In The Matter West Melton - Plan Change 67

OFFICER COMMENTS OF SHANE BISHOP

Existing West Melton Water Supply – Scheme layout

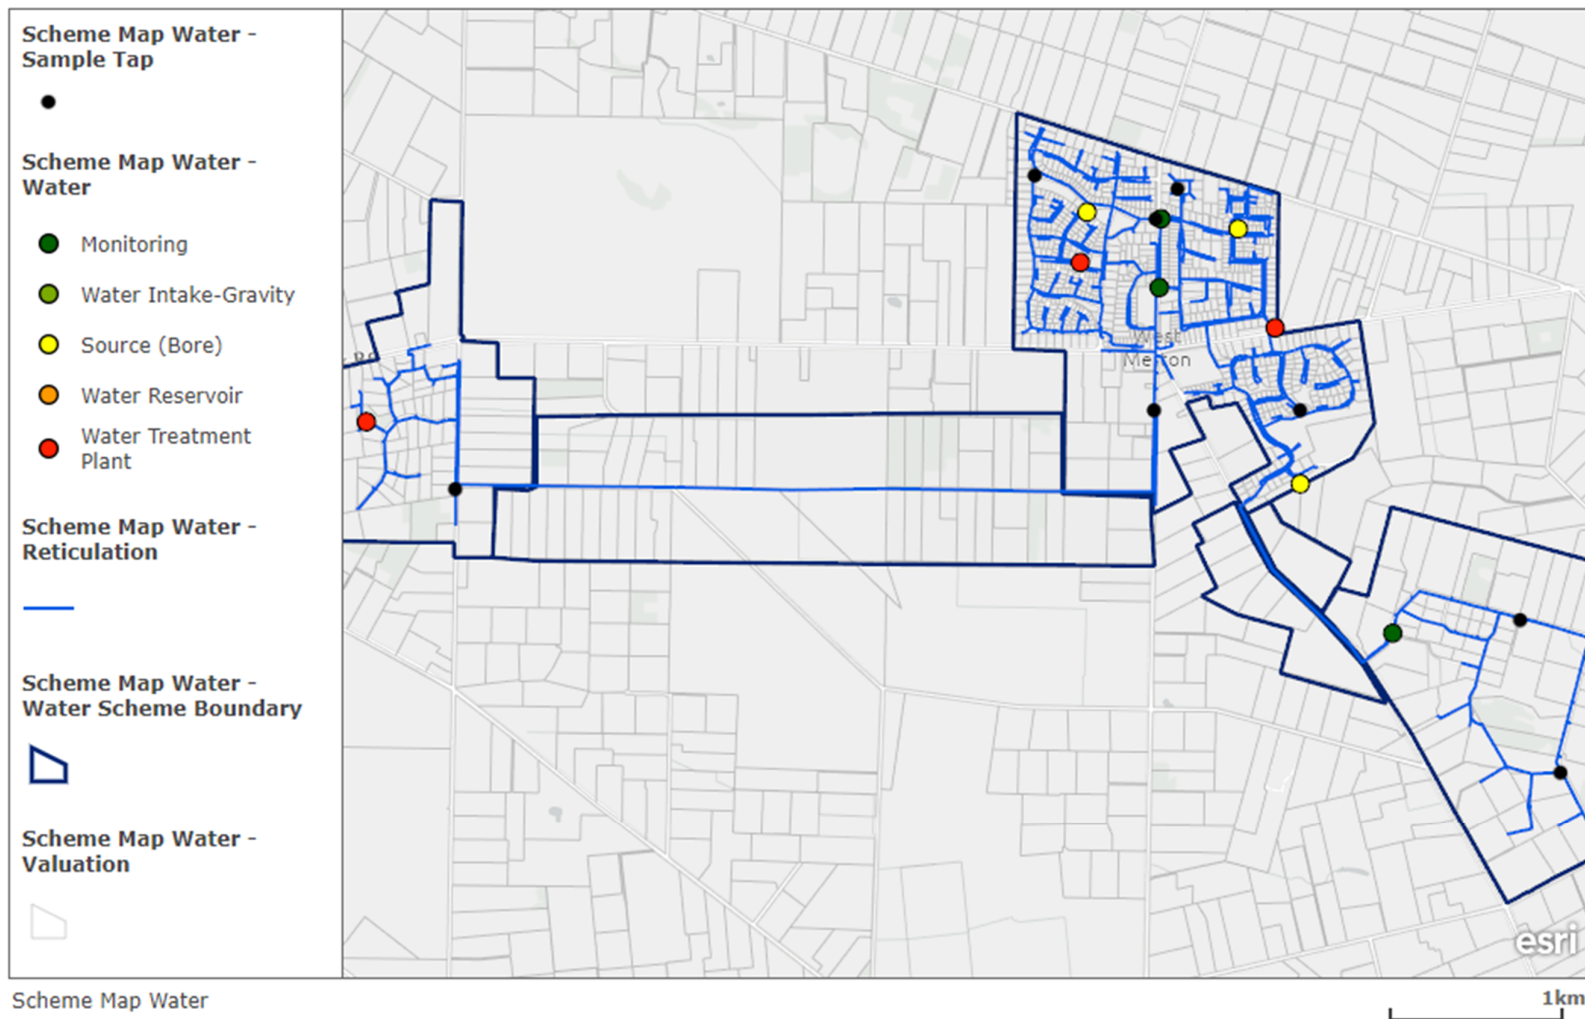
9. The water supply generally provides on-demand' connections via water meters with the exception of Johnson Road being a metered tank supply and a number of properties in West Melton are supplied through a restricted connection (**Refer Appendix 1**).

West Melton Water Supply – Planned Upgrades

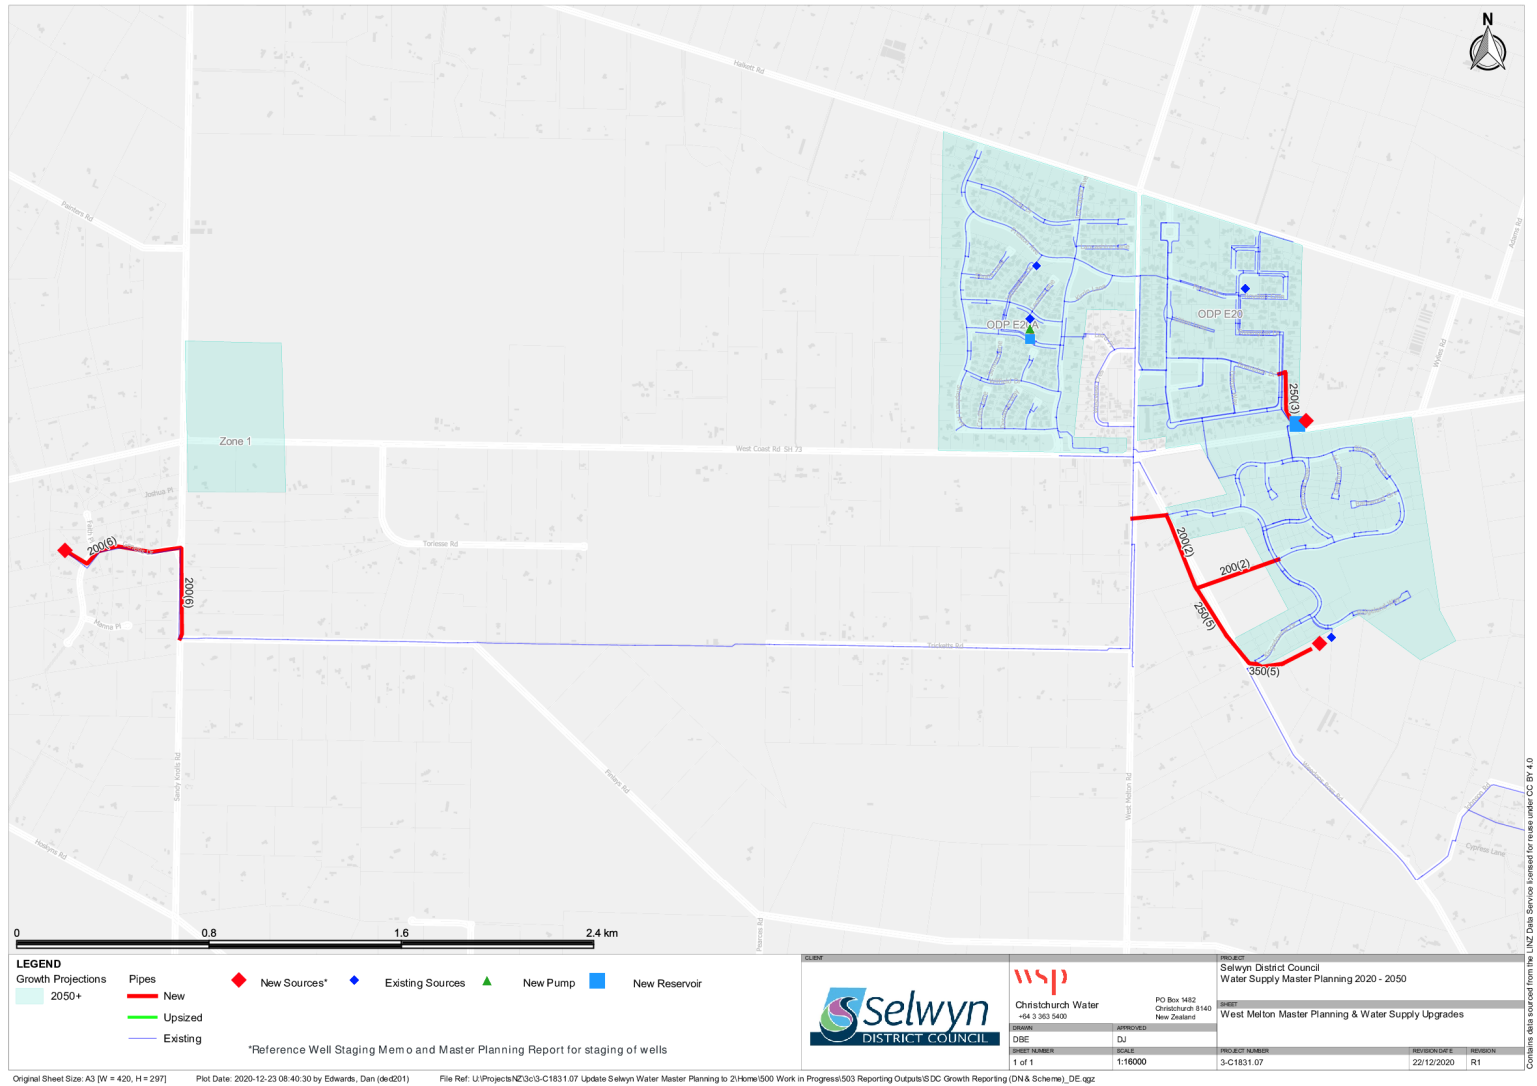
17. The master planning provides an assessment of the sizing and timing of new infrastructure for new reservoirs, water sources (bores) and pipelines to service growth. Part of the master planning requires a water balance to be developed to forecast growth, using historical peak demand per household. The water balance forecasts the peak instantaneous flow per year versus the water resources available to determine the staging of new bores (**Refer Appendix 1**).

18. West Melton is expected to see growth over the next 30-years and to meet this growth, capacity upgrades are proposed. The Council 2021 – 31 Long Term Plan which includes budget for further upgrades on the West Melton water supply to address capacity constraints.

Existing West Melton Wastewater Network - Community

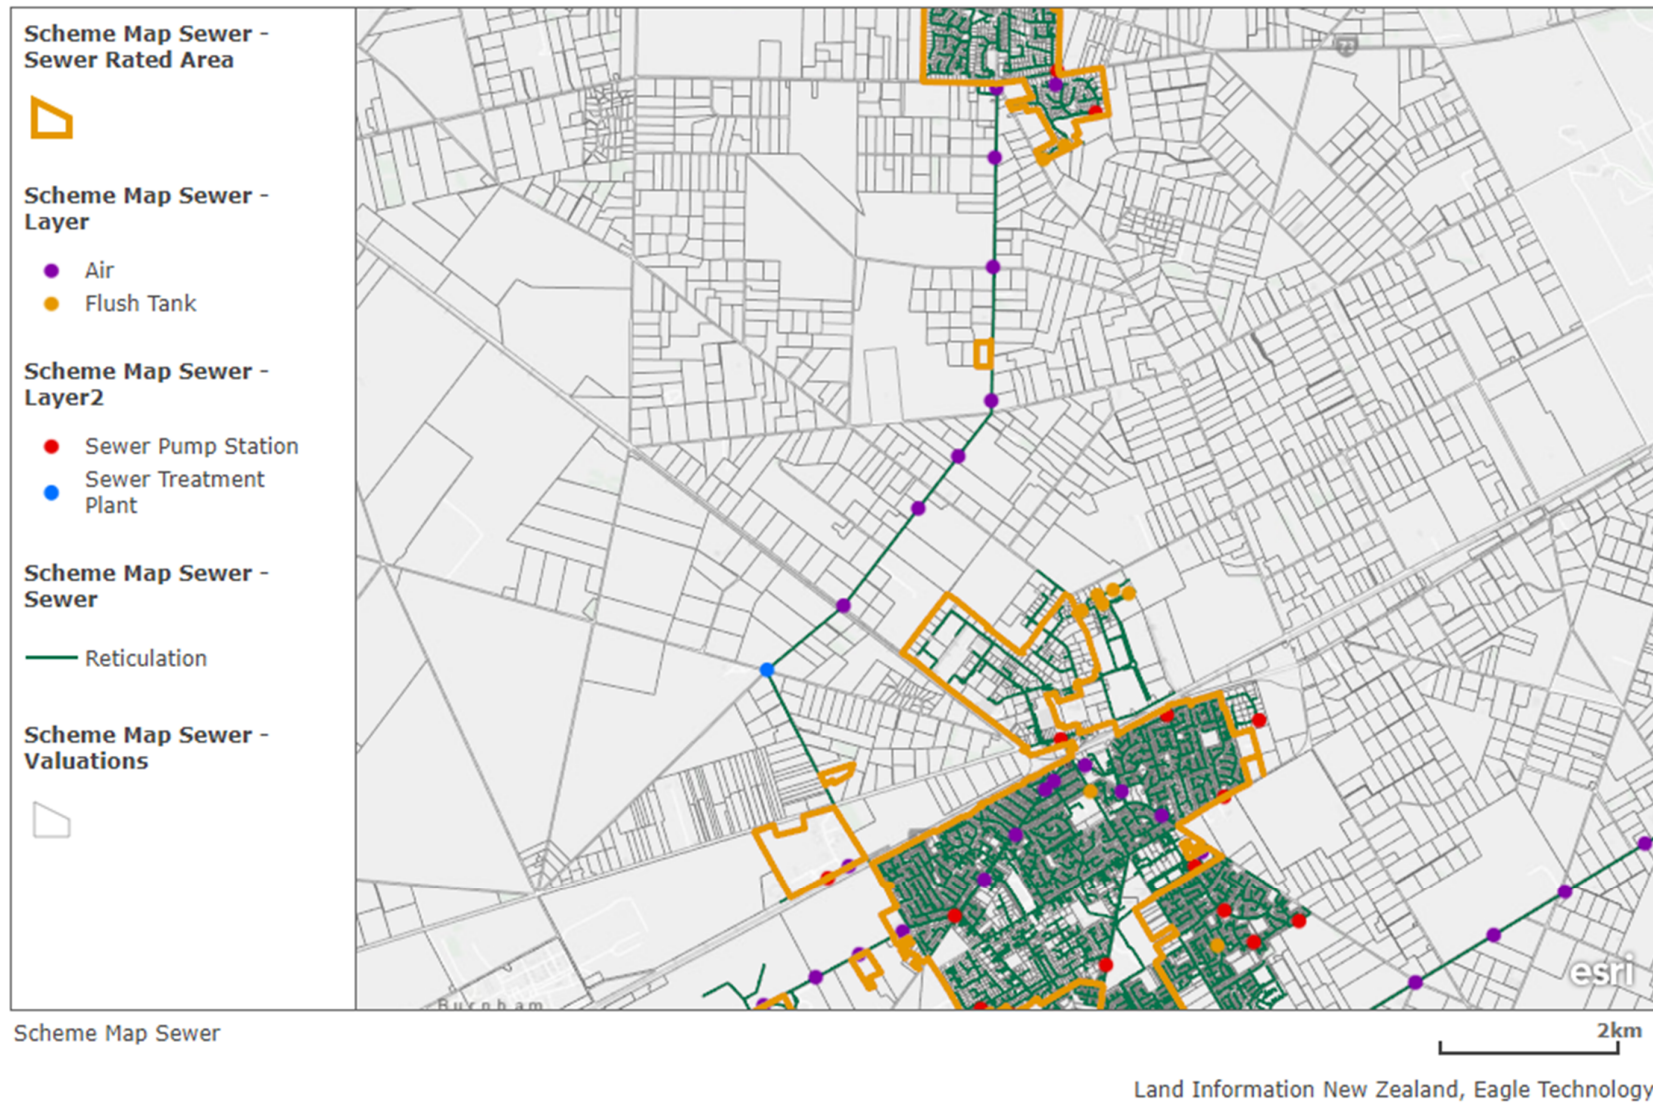
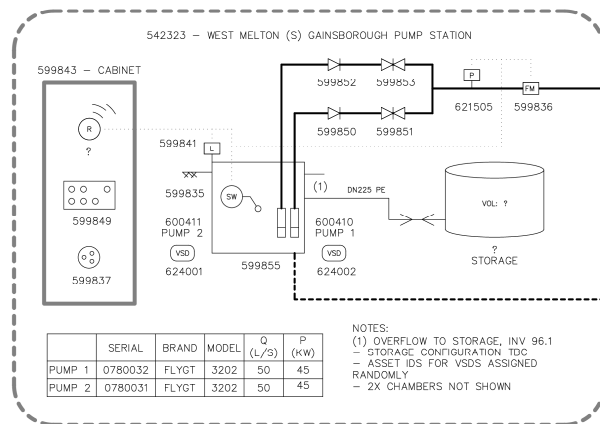
28. Conveyance of the existing wastewater system for West Melton is principally via gravity to catchment pump stations. All flows are conveyed to the current terminal pump station (Gainsborough Pump Station in Rossington Drive) which then pumps wastewater to Councils gravity manhole located at the intersection of Walkers and Runners Roads. Wastewater from West Melton ultimately discharges to the Pines Wastewater Treatment Plant (Pines WwTP) in Rolleston (**refer Appendix 2**).
